PLANNING DEPARTMENT
Staff Report & Recommendation

SUBJECT: DRB20-0551
4424 North Bay Road

An application has been filed requesting Design Review Approval for the construction of a new two-story single-family residence including one or more waivers, on a vacant site.

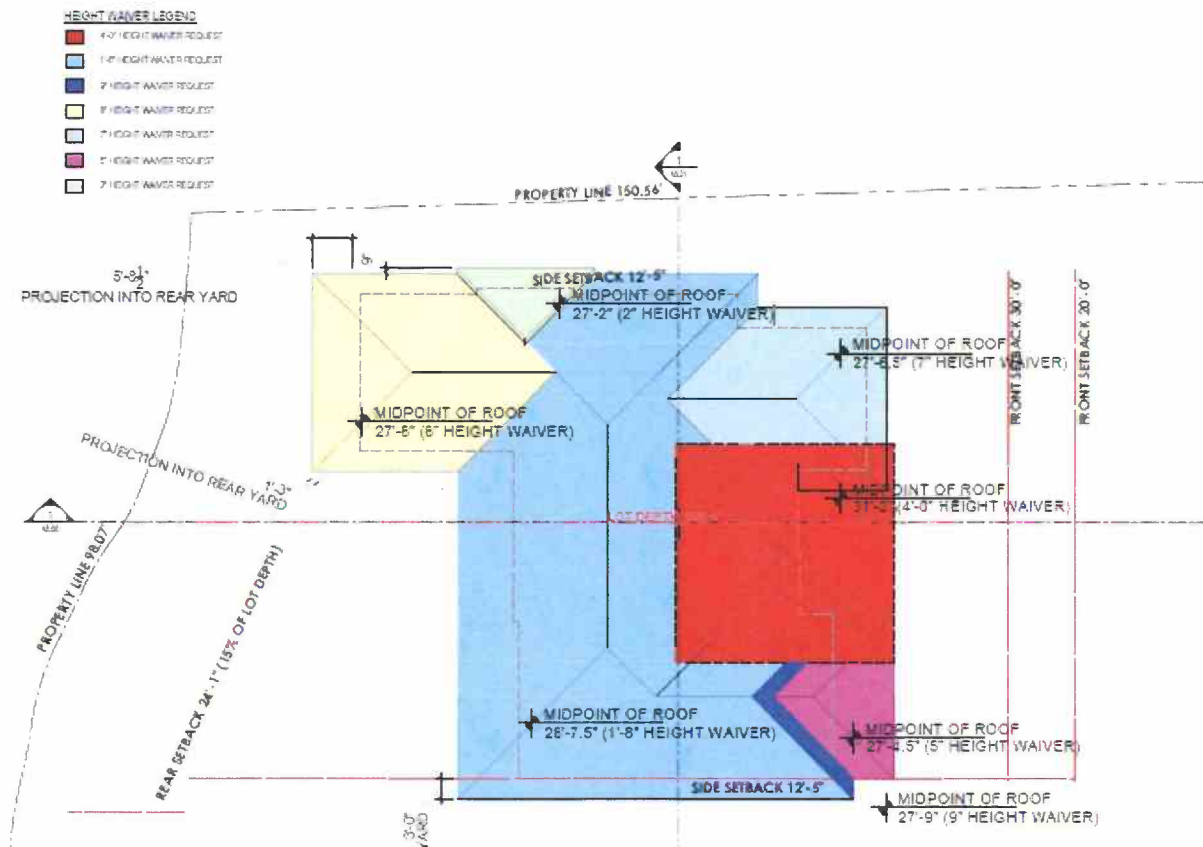
The first design waiver pertains to the height of the home. As proposed, the design features many volumes with steep hip roofs mostly compliant with the height limitation along the sides for sloped roof structures; however, one central portion of the proposal features a central pitched rooftop element proposed at 31'-0".

Given that the home is zoned RS-3 the height of sloped roofs can be increased by 4'-0", up to 31'-0" when approved by the Design Review Board. The subject site (15,856 SF) contains an area that is nearly 60% more of the lot area required for RS-3 lots (10,000 SF) but less than 2,000SF the minimum lot area size of RS-2 lots, which is 18,000SF. While typically staff would default to the minimum lot area for primary analysis of the request, it is evident that the design proposal contemplates the request and offsets the roofs heights to minimize impact and noticeability. The sides and rear of the home have varying heights ranging from 2" to 1'-8" of the height waiver. The proposed design features a dominant entrance area, the sole portion seeking the full 4'-0" height waiver, that is centrally located from the site and setback approximately 46'-0" from the front property line. In this instance, staff has concluded that the approval will have a minimal impact on the surrounding properties and is supportive of the full 4'-0" height increase waiver for the entrance roof area and other roof heights as depicted in sheet A3.04 of the submitted architectural plans (shown above).

- a. The proposed increase in height **shall** be permitted as proposed; the maximum height of the structure shall be 31'-0" when measured up to BFE + freeboard 2', or 10' NGVD to the midpoint of the sloped roof. In the event that a higher design finished floor elevation is proposed, a return to the Board shall be required to reevaluate the approved height waiver.

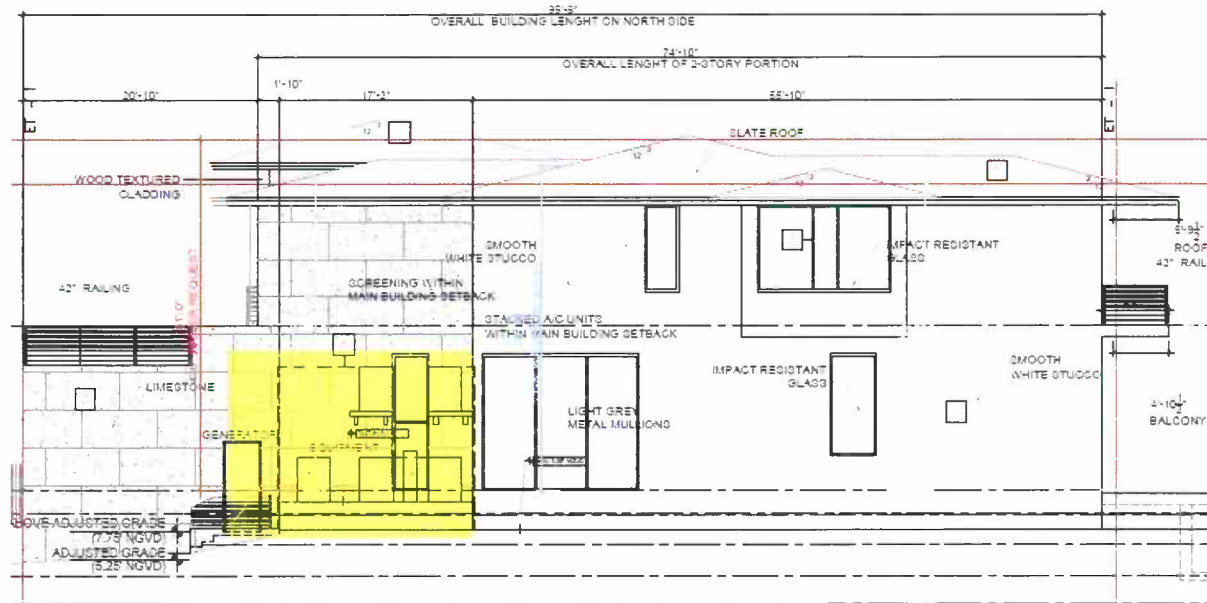
The applicant is also requesting a waiver of the open space requirement for two-story elevations that exceed 60'-0" in length. The north (side) elevation spans 95'-8" in total length

measured from northernmost wall to southernmost wall along the elevation. The ground floor spans the majority of length with a 20'-10" long one-story garage, whereas the second story is broken up with an open terrace. Since the terrace is located above a one-story portion of the home, the open space requirement does not meet the specific requirements for being "100% open to the sky" from the ground up.

The true "two-story" portions of the residence measure 74'-10" in length. As proposed, the architect has broken up the elevation resulting in an "uninterrupted" span of 55'-10". However, due to the stringent prerequisites of the open space requirements, the side elevation does not satisfy most of the criteria of the regulation. However, the design endeavors the intent of the ordinance since the designated open space successfully breaks up the massing of the two-story elevation.

- b. The proposed side (north) interior side open space requirements **shall not be** waived as proposed. The architect shall redesign the mechanical stacked portions of the equipment to be located at the same planar level as the other equipment; otherwise, staff recommends denial of the waiver.

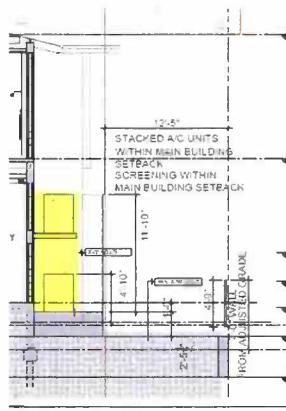
Staff does have some concern with the location of the AC equipment "stacked" along this side elevation and would recommend further study of this aspect of the design. The proposed location would likely have a visual and audible impact on the neighboring property. Staff recommends relocating the elevated stacked portions of the equipment in order to be supportive of the design waiver along the side elevation; otherwise, staff recommends denial of the waiver so that the side recess be increased to meet code requirements and better accommodate the stacked mechanical equipment in order to mitigate the impact on the neighboring property.
